RAMP REPORT REGION 2 ADA 2026

Route 7 – Vine Street
Belfast

CR16781

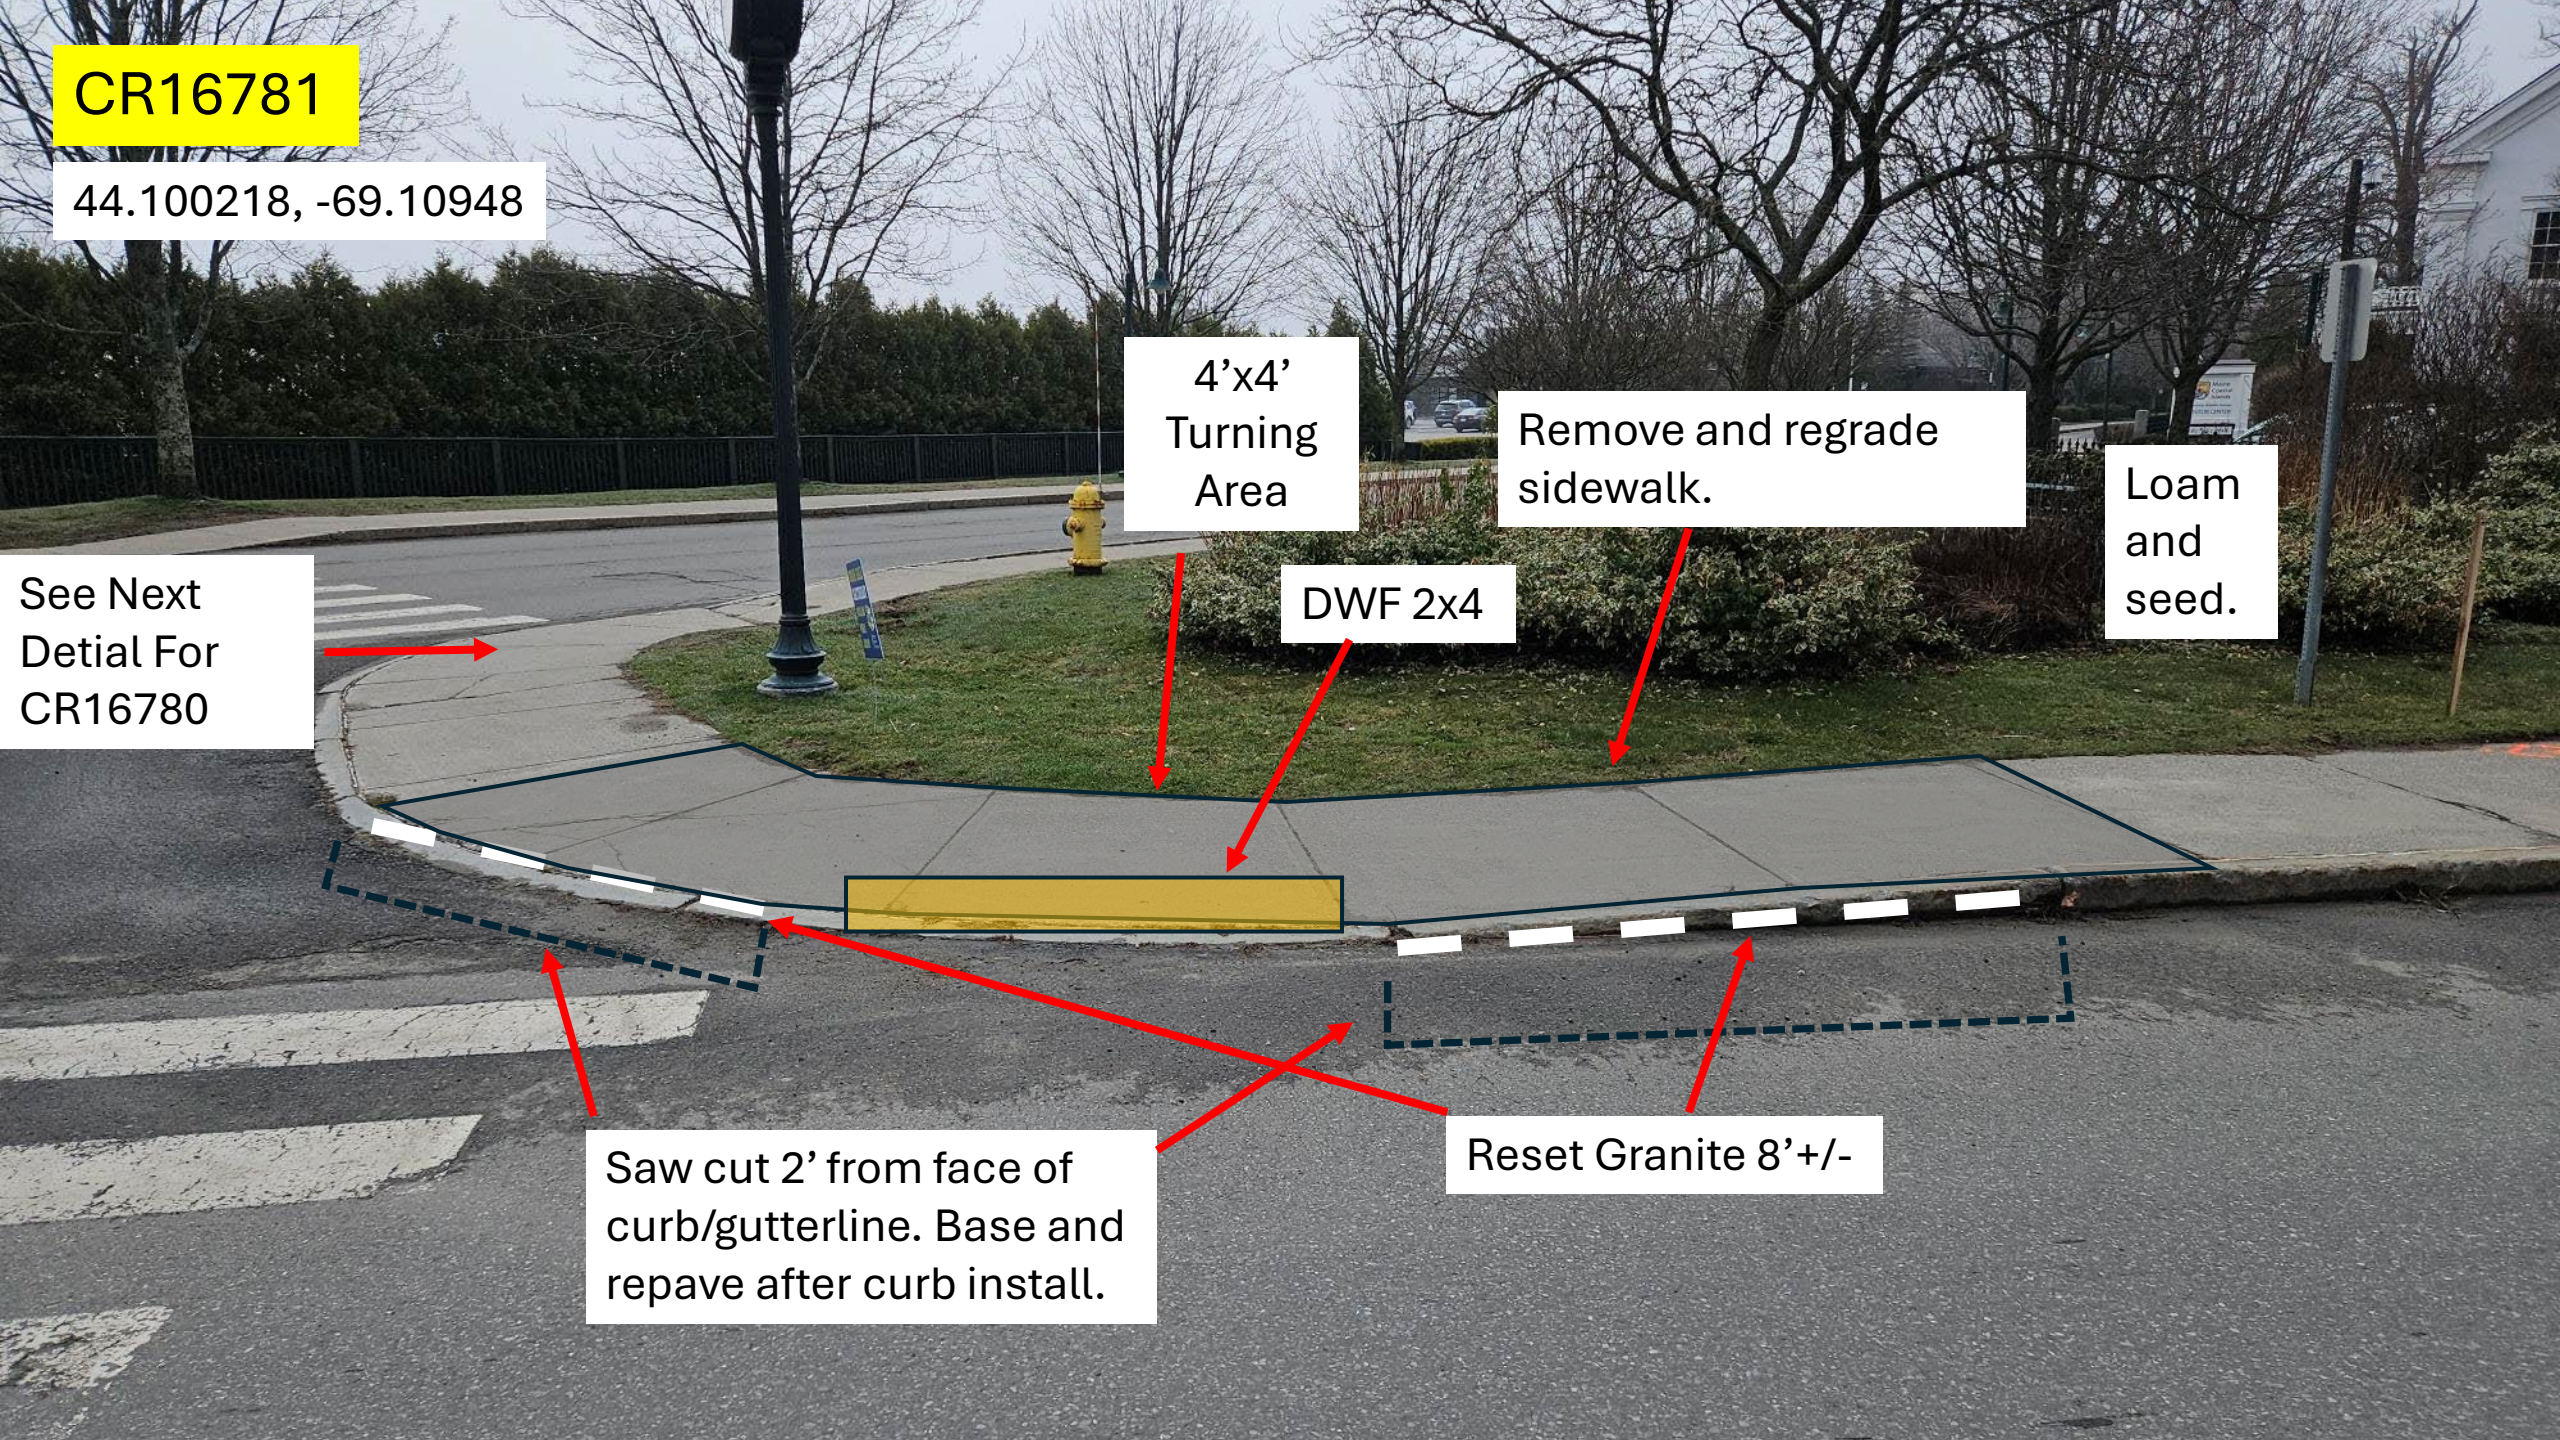
4'x4'
Turning
Area

Remove and regrade
sidewalk.

Loam and
seed.

DWF 2x4

Saw cut 2' from face of
curb/gutterline. Base and
repave after curb install.

Reset Granite 8'+/-

CR16780

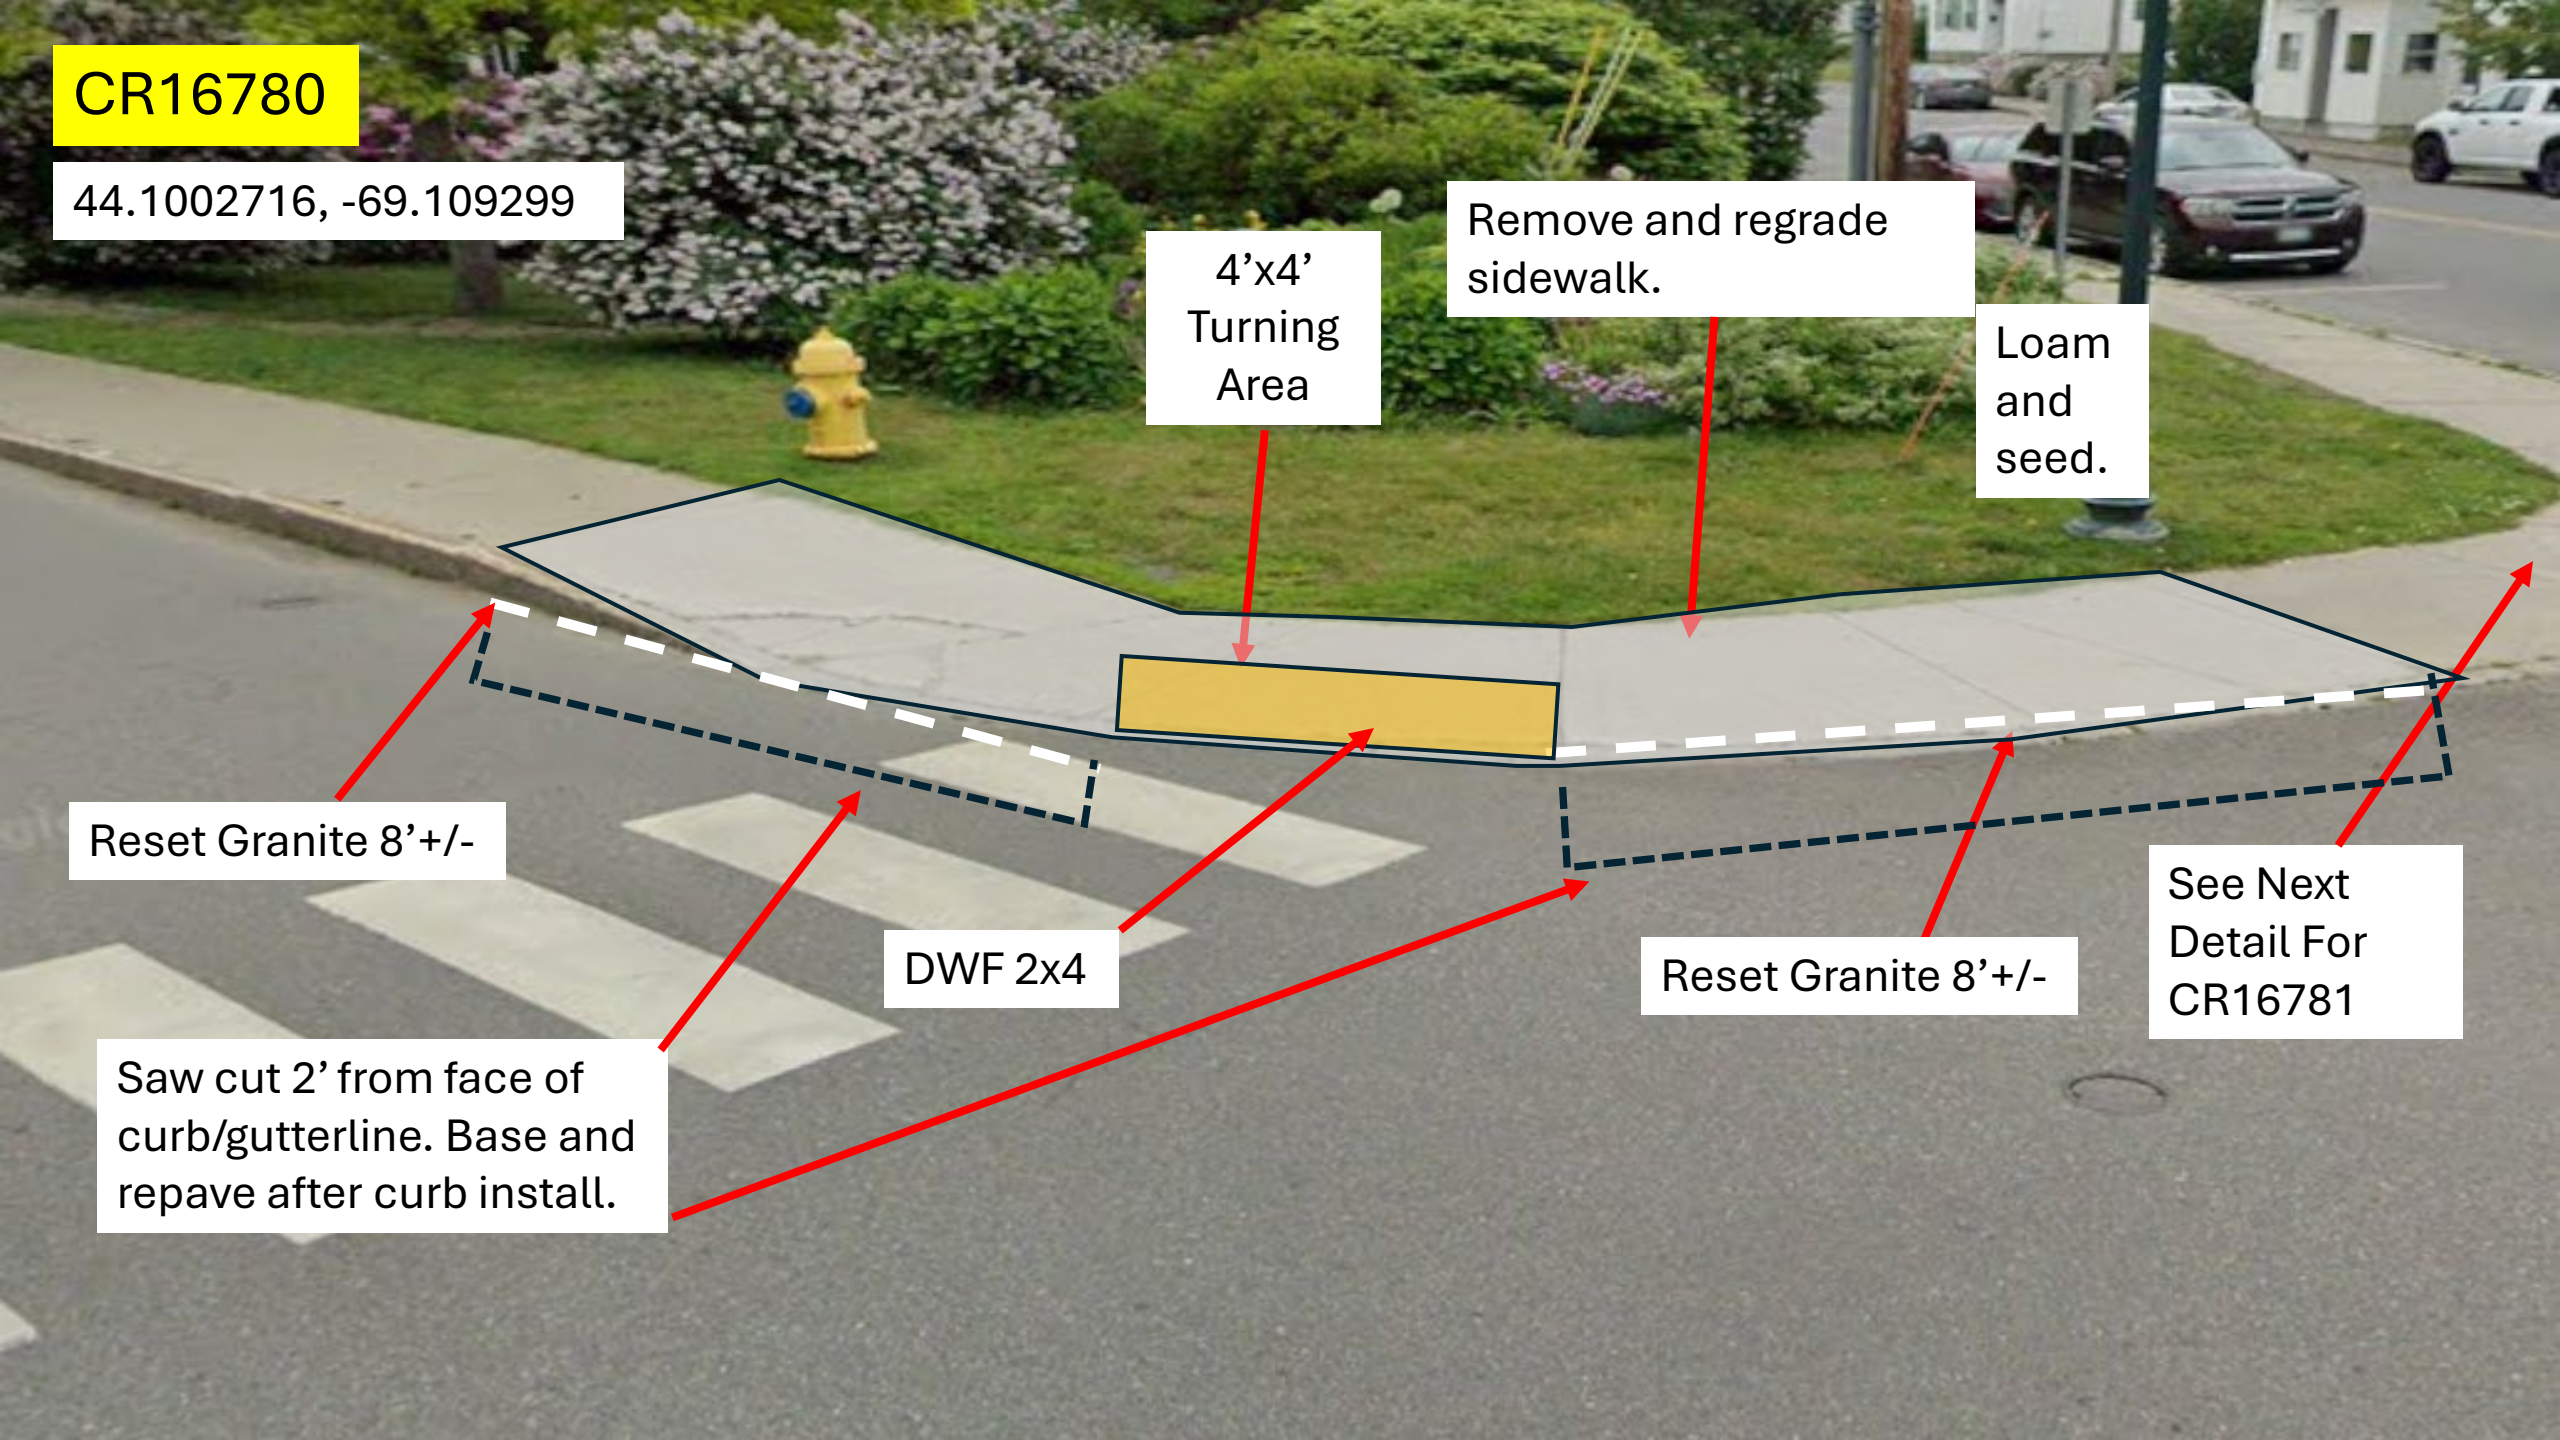
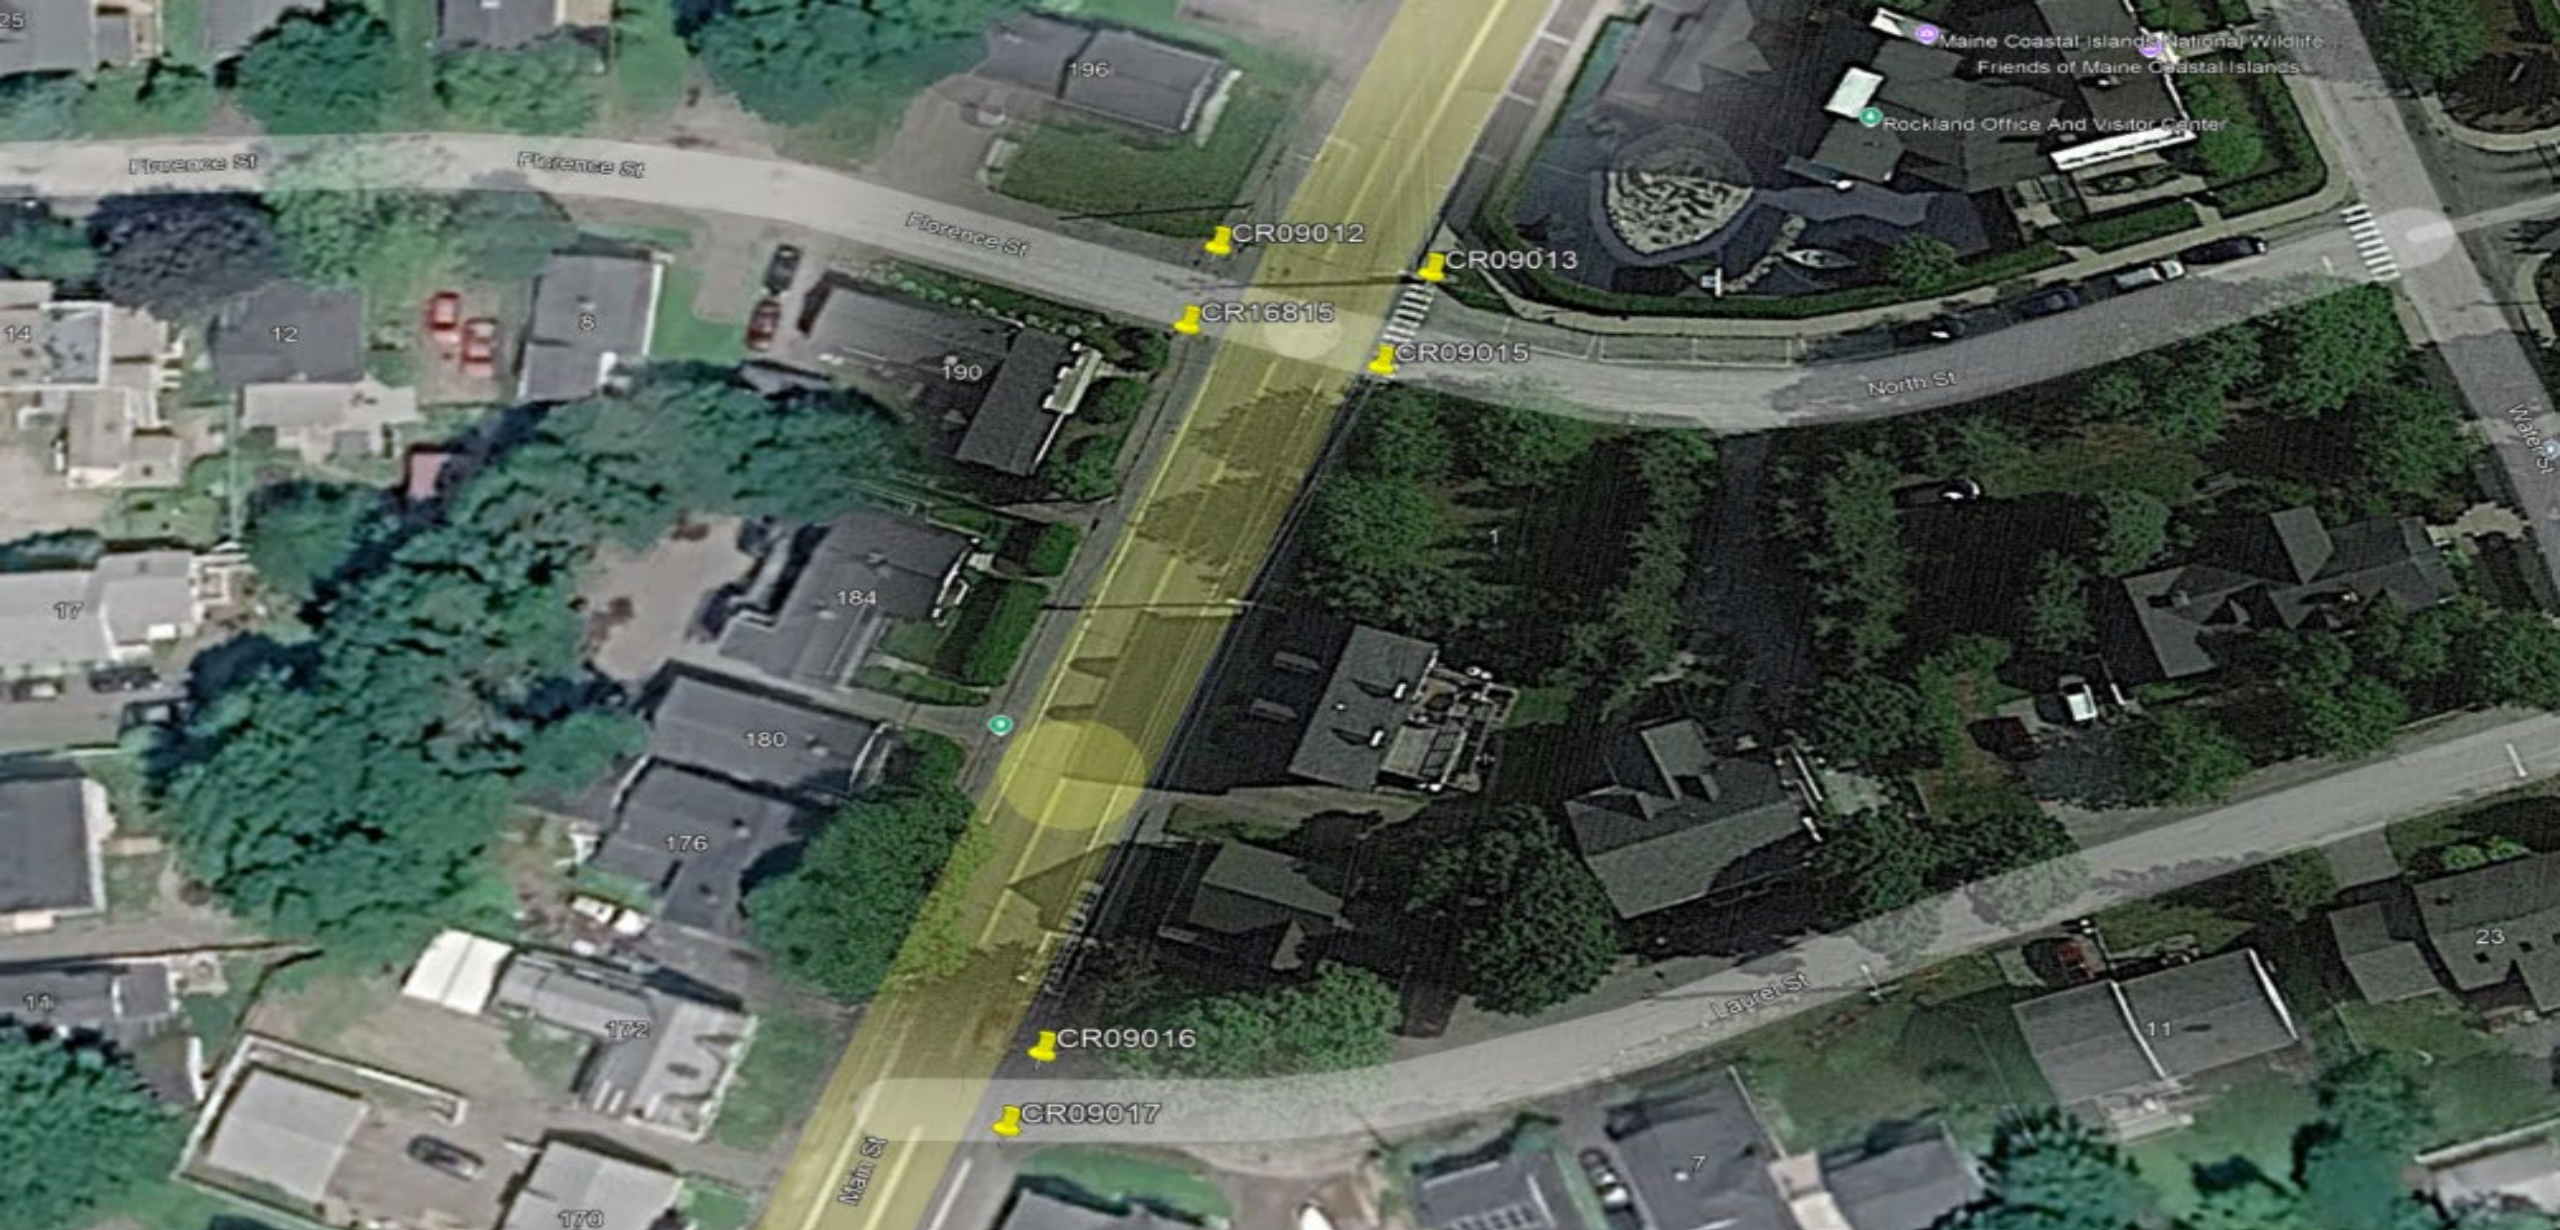
4'x4'
Turning
Area

Remove and regrade
sidewalk.

Loam
and
seed.

Reset Granite 8'+/-

DWF 2x4

Reset Granite 8'+/-

Saw cut 2' from face of
curb/gutterline. Base and
repave after curb install.
